**TOWN OF NEWBURGH
PLANNING BOARD
TECHNICAL REVIEW COMMENTS**

PROJECT NAME: TARBEN II SUBDIVISION
PROJECT NO.: 2021-18
PROJECT LOCATION: SECTION 127, BLOCK 1, LOT 12
REVIEW DATE: 12 JULY 2024
MEETING DATE: 18 JULY 2024
PROJECT REPRESENTATIVE: JOHNATHAN CELLA, P.E.

Re.: **Proposed Two (2) Lot Residential Subdivision for Lynn Warren
Tarben Way, Lot 12 Filed Map 274.16 (S/B/L: 127-1-2)
Town of Newburgh Planning Board Application # 21-18**

TREE SURVEY

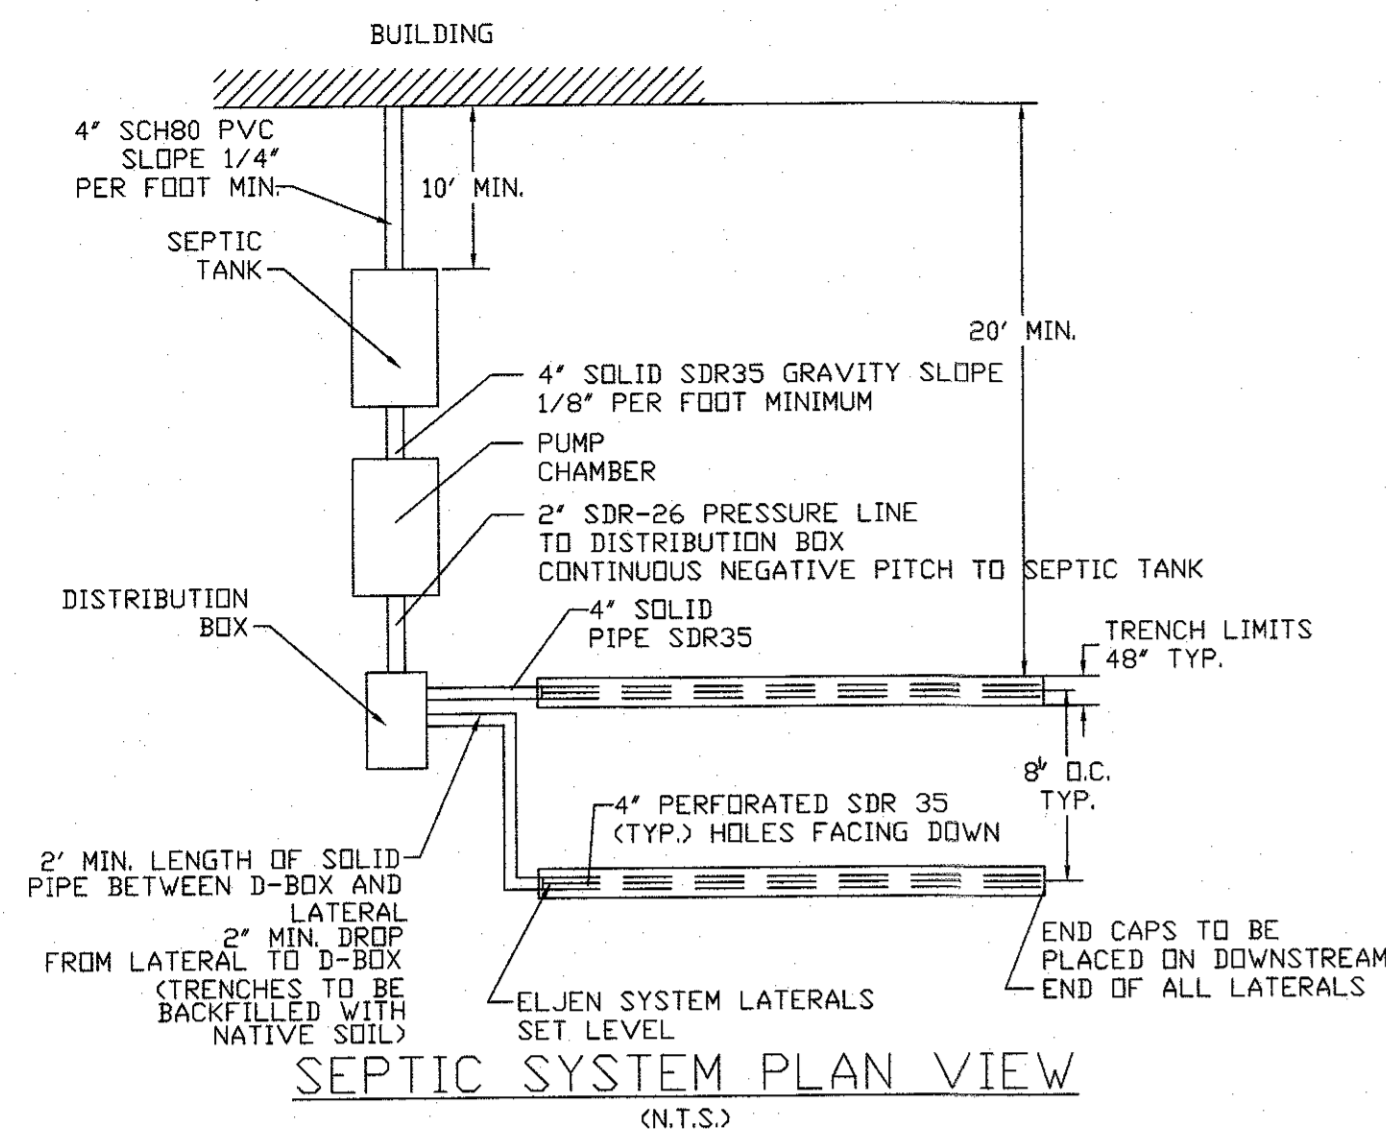
1. The applicant's representative have provided a Tree Preservation Plan. The Tree Preservation Plan should note the consultant that prepared the Tree Preservation Plan in accordance with the ordinance. Noted, the Tree Preservation Plan was performed only in the areas of disturbance on the new lot, Lot #11. Trees to remain within the limits of disturbance should have the appropriate tree protection detail added to the plans.
2. An emergency vehicle turn-around has been designed for the existing structure on Lot #12.
3. The building envelope on Lot #11 has been revised to the point where the lot has minimum lot width. The Highway Superintendents comments on the driveway location should be received.
4. The project requires a Public Hearing, which can be scheduled after a SEQRA determination is made.
